SUBJECT: Request for Additional Information to Support  
Request for Exception to NUREG-0696 Guidance on  
Emergency Operations Facility (EOF) Location  
Oconee Nuclear Station  
Docket Nos. 50-269, 270, 287  
License Numbers NPF-38, NPF-47, NPF-55

**REVISED JANUARY 19, 2005 RAI RESPONSES  
(Re: April 21, 2005 Letter)**

**FIGURE B-11  
DUKE ENERGY COMPANY  
OCONEE NUCLEAR SITE**

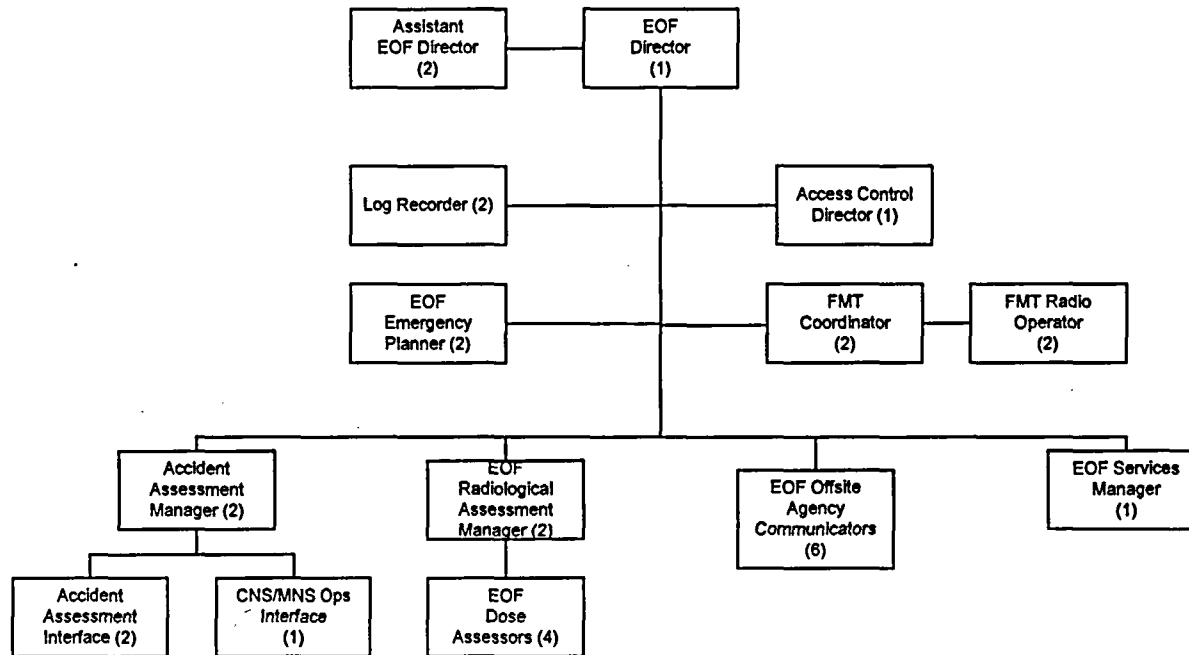
**Common EOF  
Multi-Site Event Staffing**

1. Pagers activated for second unit - all call response
2. Assistant EOF Director assumes responsibility as lead manager for designated site
3. Additional Log Keeper retained to support 2<sup>nd</sup> Site

4. Additional Accident Assessment Manager retained to support 2<sup>nd</sup> Site
5. Additional Dose Assessor retained to support 2<sup>nd</sup> Site
6. Additional FMT Coordinator retained to support 2<sup>nd</sup> Site

7. Additional FMT Radio Operator retained to support 2<sup>nd</sup> Site
8. Four additional Offsite Communicators as needed to support both sites
9. Additional Emergency Planner as needed to support 2<sup>nd</sup> Site

10. Additional Radiological Assessment Manager as needed to support 2<sup>nd</sup> Site
11. Additional Assistant EOF Director as needed to support 2<sup>nd</sup> Site

12. Oconee Ops Interface position is staffed in the ONS TSC
13. Additional Accident Assessment Interface as needed to support 2<sup>nd</sup> Site
